SUBJECT: INTEGRATED PLANT SAFETY ASSESSMENT REPORT SECTION 4.4,
WIND AND TORNADO LOADINGS, SECTION 4.7, TORNADO
MISSILES - MILLSTONE UNIT 1

SAFETY EVALUATION BY
THE OFFICE OF NUCLEAR REACTOR REGULATION
MILLSTONE UNIT 1
INTEGRATED PLANT SAFETY ASSESSMENT REPORT (IPSAR)
SECTION 4.4, WIND AND TORNADO LOADINGS
SECTION 4.7, TORNADO MISSILES
DOCKET NO.: 50-245

TORNADO AND STRAIGHT WIND HAZARD
PROBABILITY MODEL FOR HADDAM NECK - MILLSTONE
POWER REACTOR SITE, CONNECTICUT

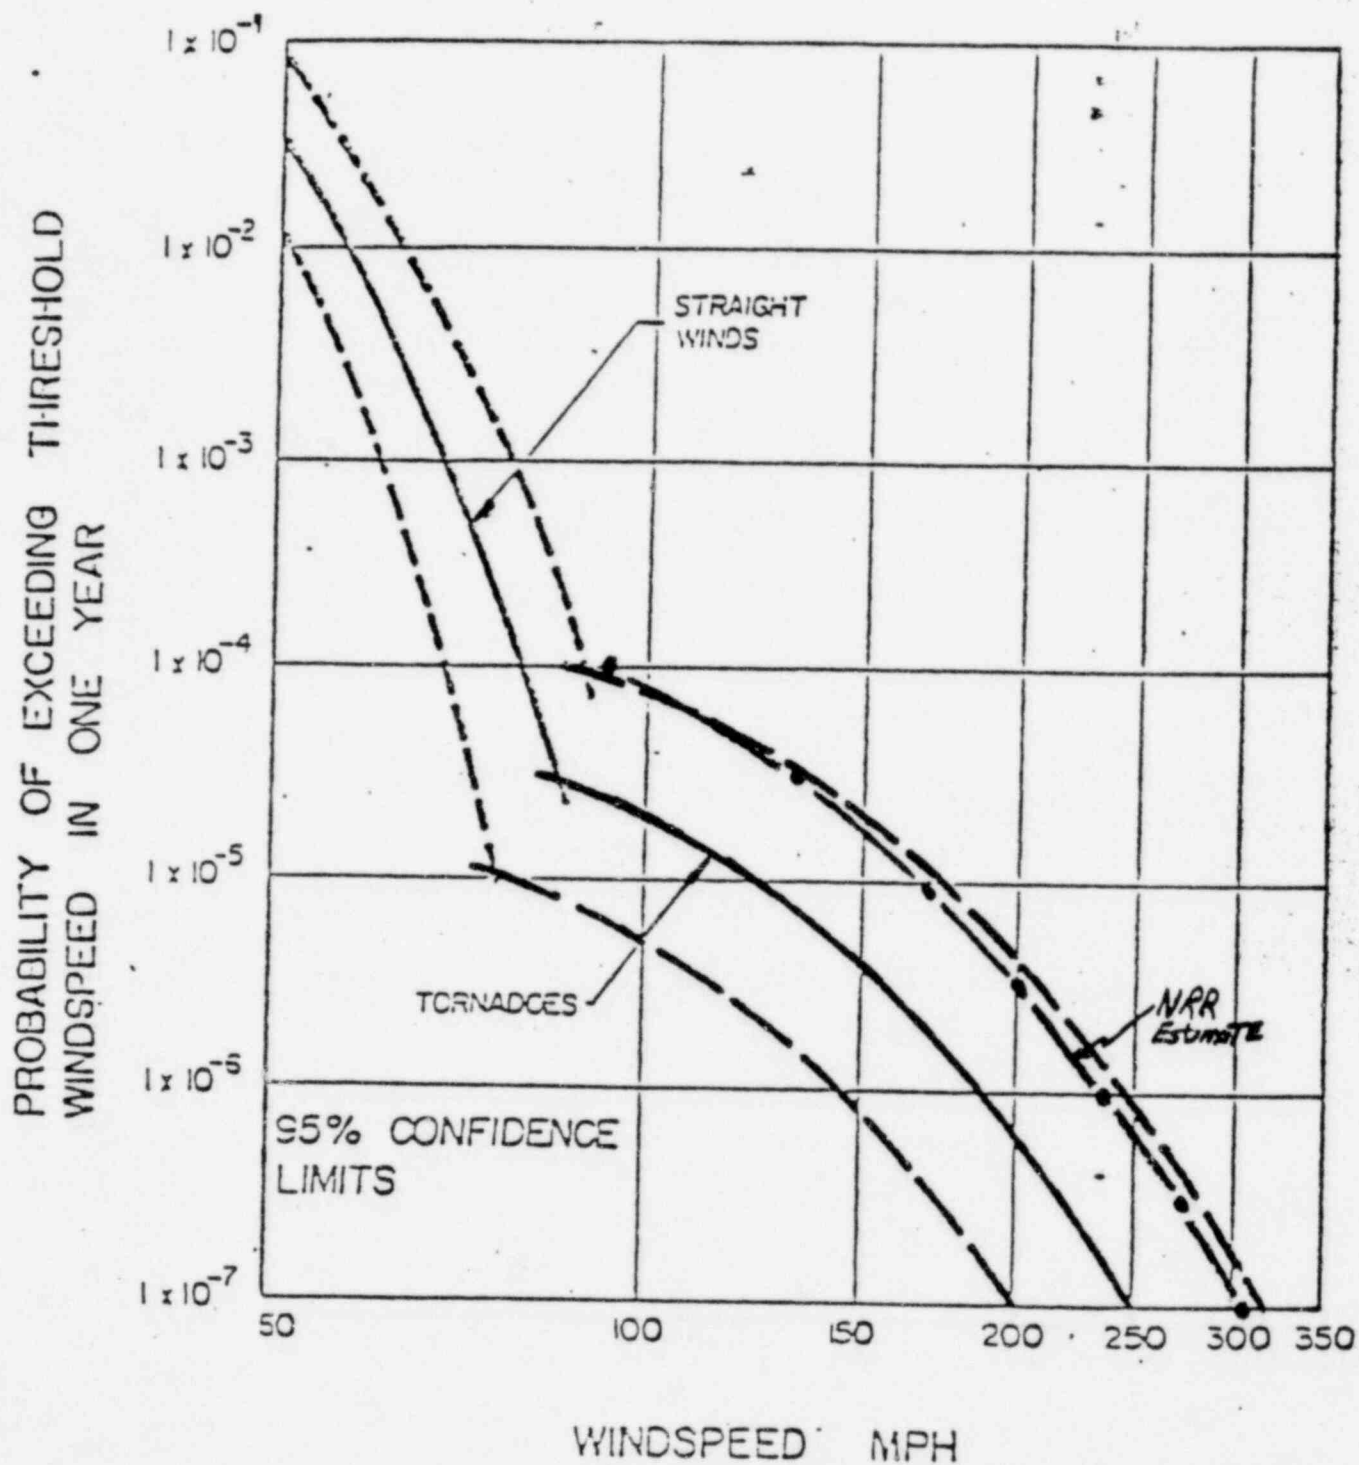
Under SEP Topic II-2.A, "Severe Weather Phenomena", the staff provided the site-specific tornado and straight wind hazard function considered appropriate for the Millstone 1 site. The curve provides the probability of exceeding a threshold windspeed in one year versus windspeed. An analysis was performed by Dr. McDonald under contract to the staff. As discussed in Topic II-2.A and in the IPSAR, the McDonald curve corresponding to the 95% confidence limit would be used by the staff to assess the tornado hazard at Millstone 1.

More recently, the staff completed an independent assessment of the tornado hazard conducted in the same manner that is currently used in licensing. The results are superimposed on the McDonald curve in Attachment 1. As can be seen, the NRR estimate is very close to the upper 95th percentile estimate developed by McDonald that was previously supplied to the licensee under SEP Topic II-2.A. Because of the good agreement in analyses results, conclusions presented in this evaluation can be considered to be based on either the NRR estimate or McDonald's upper 95th percentile estimate; i.e. the probability per year of exceeding the windspeeds listed in this evaluation.
